Subject: Changes to Emergency Plan Implementing Procedures – March 17, 2003

Grand Gulf Nuclear Station
Docket No. 50-416
License No. NPF-29

GNRO-2003/00020

GGNS EVACUATION MAP

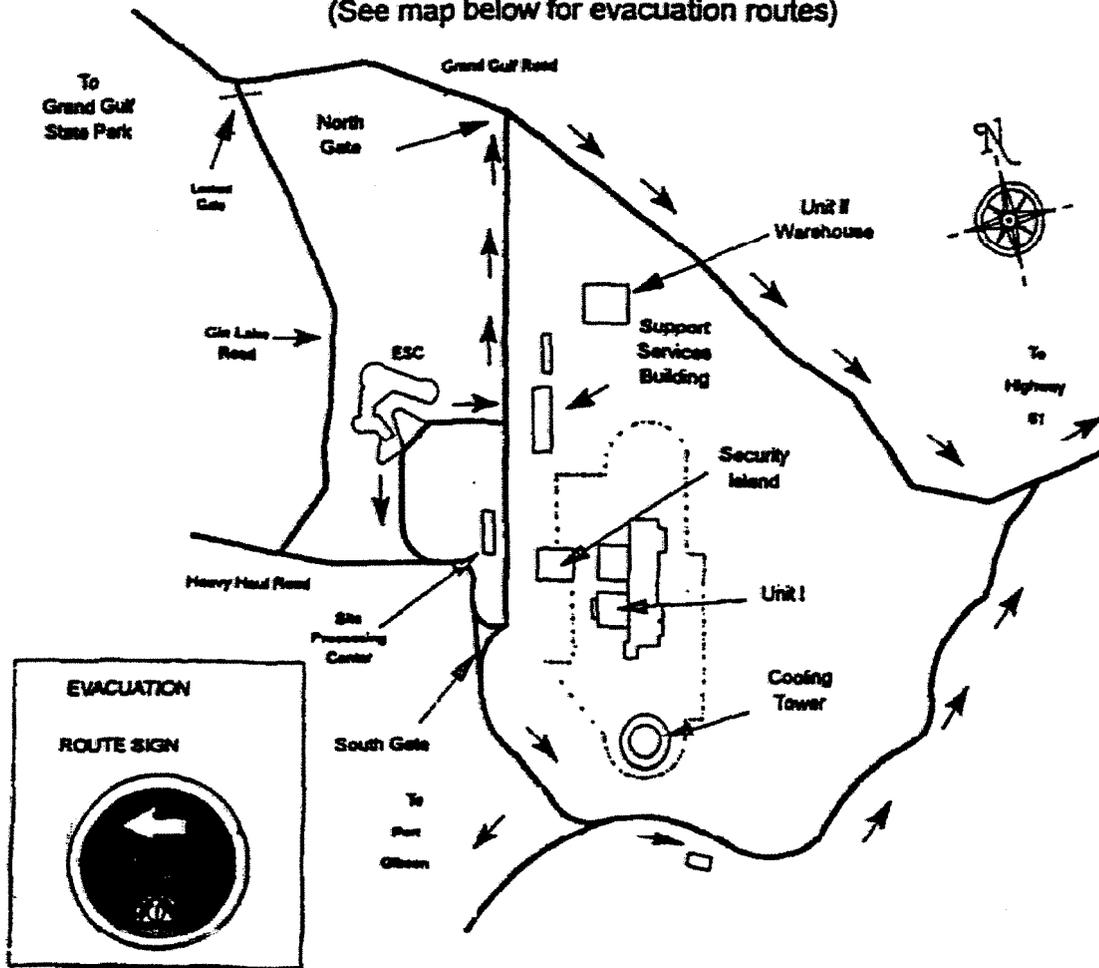
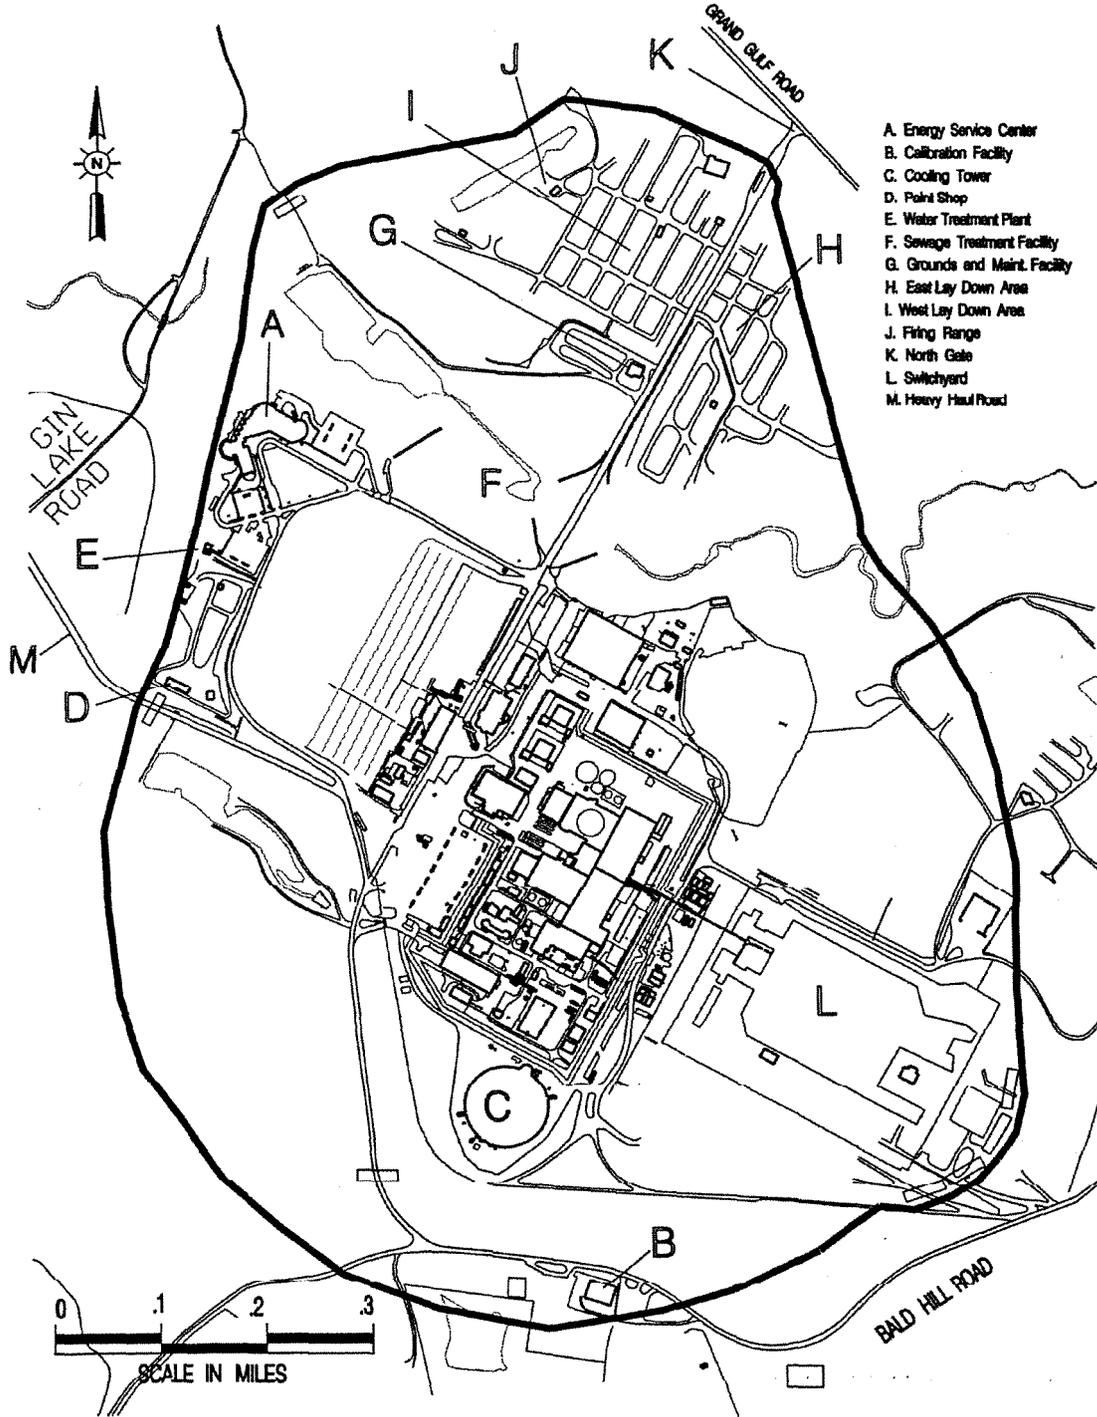
Description of Proposed Change. Adds the definition of Company Owned Property and Emergency Preparedness Owner Controlled Area. Adds time requirement to complete site evacuation notification. Adds PA system to equipment security used for notifying personnel of a site evacuation. Removes "Based on availability of security personnel". Security dedicates a security officer to perform notification at the beginning of a site evacuation. Adds information to the limited evacuation about notifying security first unless personnel safety is an issue. Adds diagram of the Emergency Preparedness Owner Controlled Area in Attachment II. Other administrative changes.

The EP Owner Controlled Area includes Heavy Hall Road from the plant to Radial Well #1, though not shown on drawing.
